# SERVICE No. 1172 BULLETIN

Date: July 3, 2006

**LIFT STRUT ATTACHMENT BOLT INSPECTION**

**Figure 1**  
Acceptable for up to 500 hours of operation.

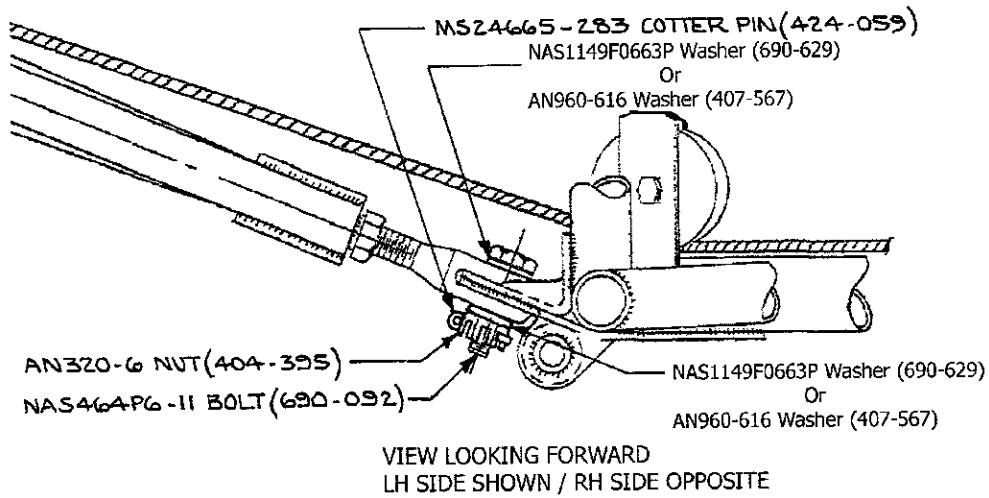
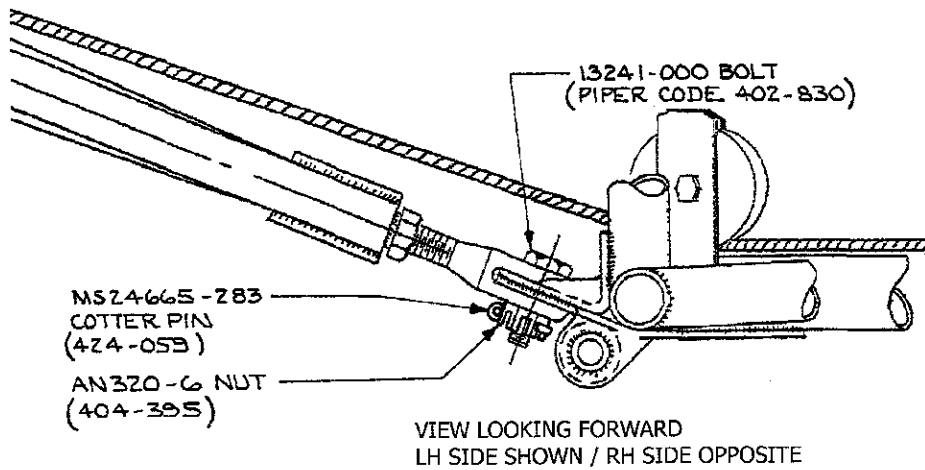
A small number of aircraft were delivered from the factory with the hardware configuration shown in Figure 1. Although this configuration does provide adequate clearance from the landing gear as delivered from the factory, it does not provide as much clearance as the configuration shown in Figure 2. Therefore, aircraft conforming to the hardware configuration shown in Figure 1 are more likely to have an interference condition occur when Parts Manufacturer Approval (PMA) parts are used in place of Piper-approved parts.

1. Locate the bolted joints (total 4 per aircraft) at the lower end of the Front & Rear Lift Strut Assemblies, left and right hand sides of the aircraft, and compare to Figure 1 and Figure 2 below.

Note the orientation and stack-up of nut, bolt, cotter pin (and if applicable, washers) at this bolted joint. Bolts will have head markings as follows:

For Figure 1, the bolt head marking reads NAS 464P.

For Figure 2, the bolt head marking reads 13241.

2. Aircraft conforming to Figure 1 are acceptable for use up to 500 hours of operation, as a temporary measure, to allow time for the operator to order and install the hardware shown in Figure 2.

This Service Bulletin provides for the mandatory inspection (and if necessary, replacement) of the Lift Strut Attachment Bolts, to insure that the hardware configuration of all affected aircraft are in agreement with Figure 2.

**After 500 hours of operation, all aircraft must conform to Figure 2.**

**Note:** If re-installation of the castellated nut (Piper Code 404-395) is needed, tighten nut just enough to eliminate axial play in bolt, then continue tightening nut as needed to align cotter pin hole in bolt with nearest nut castellation. Install cotter pin.

3. After verifying that the lift strut attach bolts at all 4 locations on the aircraft are in agreement with Figure 2, make a logbook entry indicating compliance with this Service Bulletin.
